Docket No.: P2002,0659

Applicant : Wolfgang Henke et al.  
Applic. No. : 10/637,193  
Filed : August 8, 2003  
Title : Method for the Characterization of an  
Illumination Source in an Exposure Apparatus

REQUEST TO APPROVE DRAWING CHANGES

FIG 1

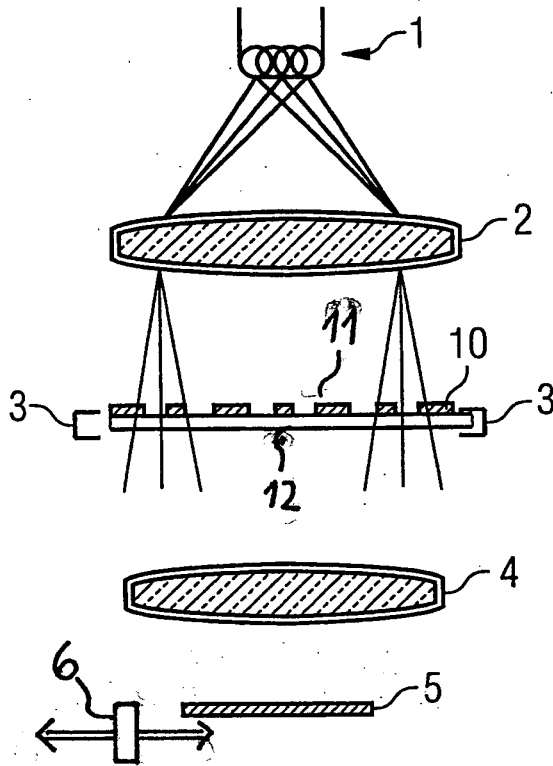
This preliminary amendment is filed to designate the sensors mentioned on page 17 of the specification with reference numeral 6. Accordingly, Fig. 1 is amended as well to show the sensors illustrated with reference numeral 6 and to add reference numerals 11 and 12 thereto. A *Request to Approve Drawing Changes* is attached hereto.

Enclosed please find two (2) sheets of drawings. In the informal drawing of Fig. 1, the changes are highlighted in yellow. Specifically, reference numerals 11, 12 and the sensors 6 were added. These changes are formalized in the attached formal drawing. Approval of the changes is respectfully requested.
